MOULTON CREEK DAM NO. 1 MT -1467

BASIN CREEK DAMS NO'S 1 AND 2 MT-374 MT-868 BUTTE, MONTANA

SEATTLE DISTRICT, U. S. ARMY CORPS OF ENGINEERS

DAM SAFETY INSPECTION

BASIN CREEK DAM NO. 1
PLAN & SECTION

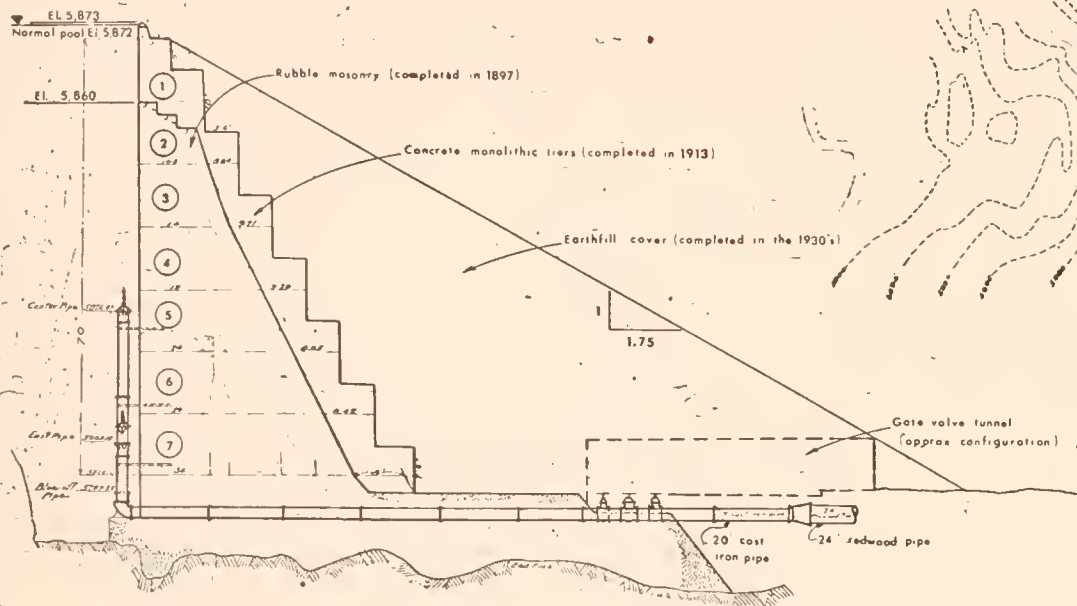
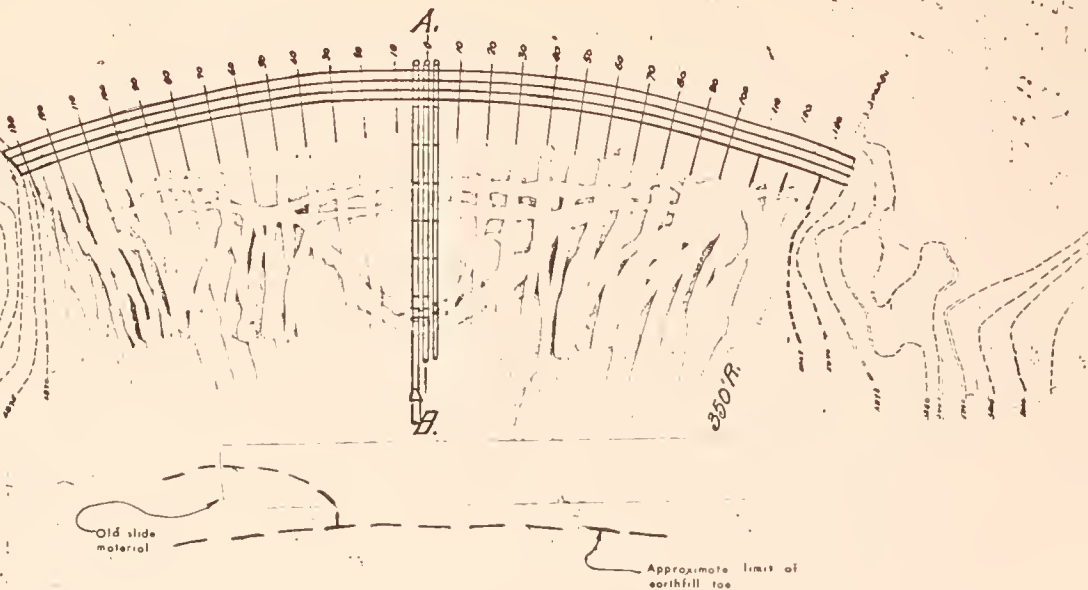
Drawing has been modified to show conditions observed on 10 May 1978.

BASIN CREEK DAM NO. 2

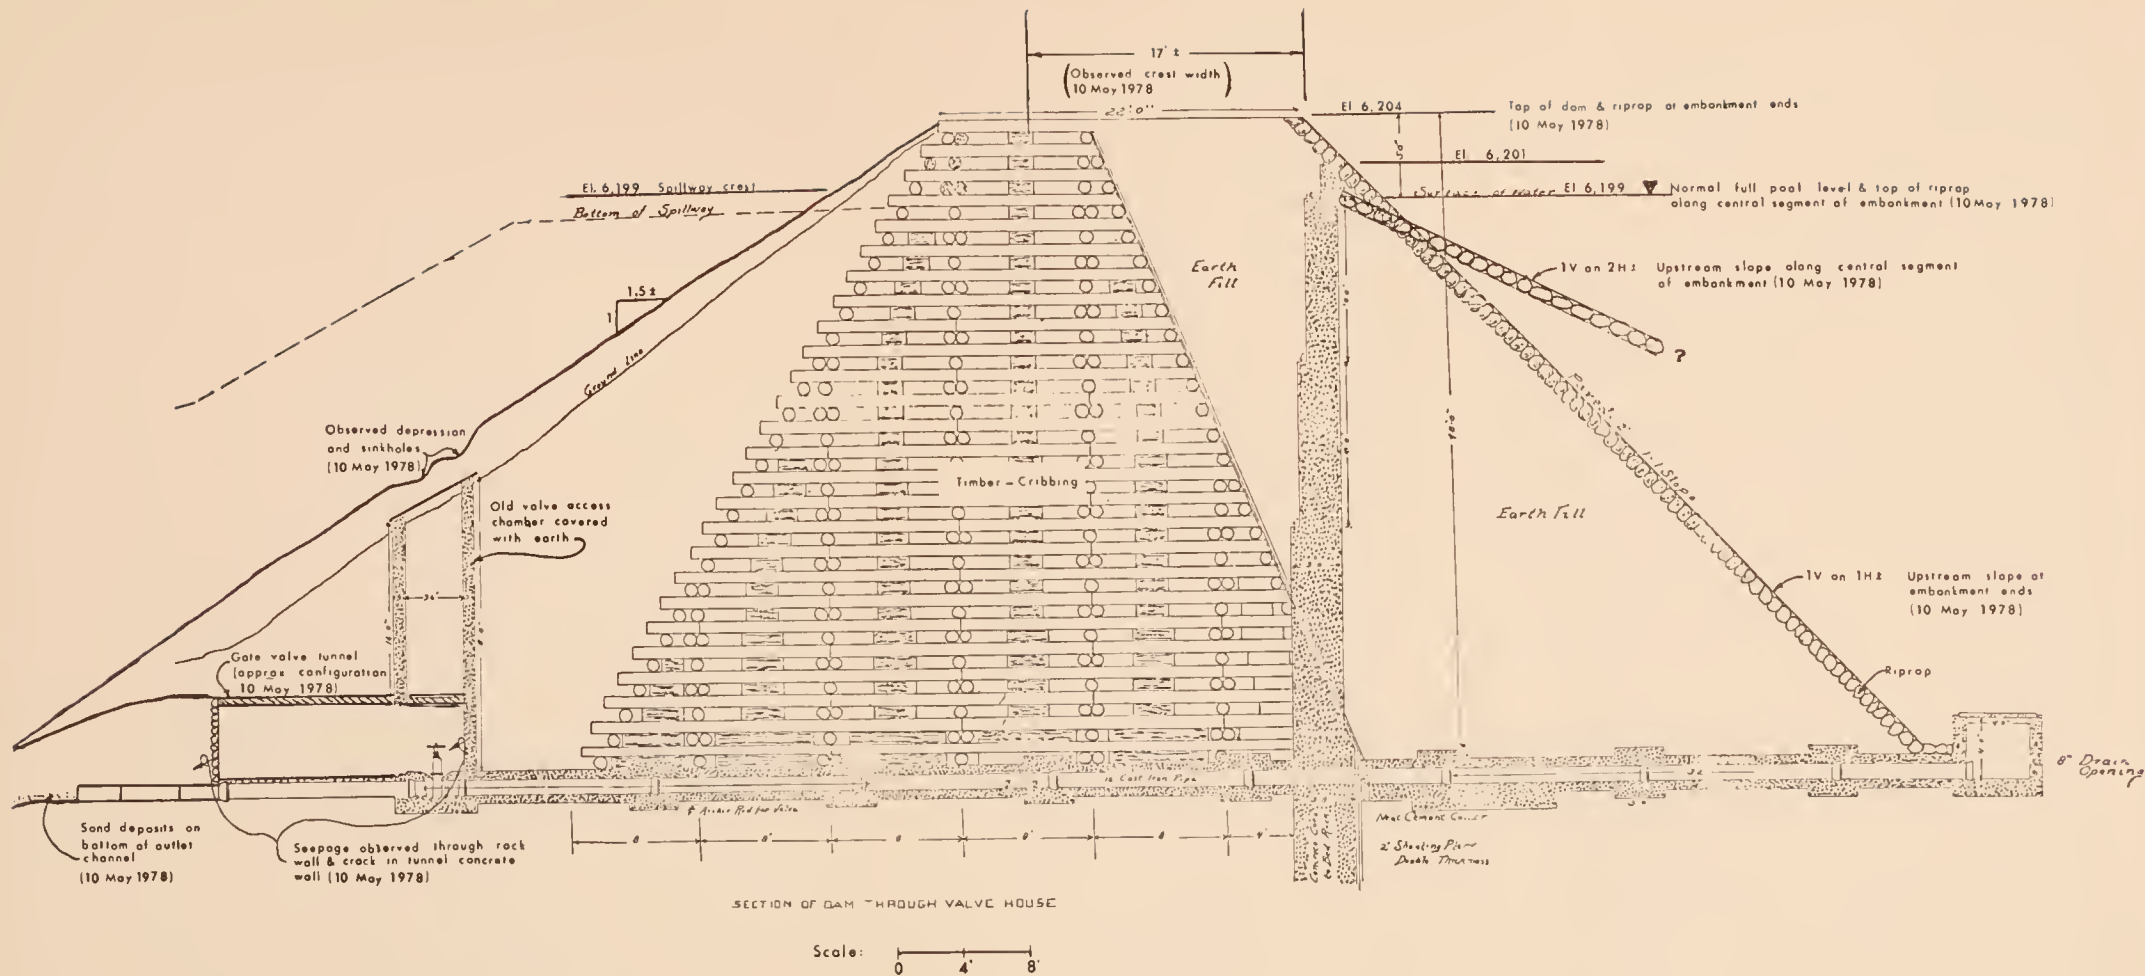
Drawing has been modified to show
conditions observed on 10 May 1978
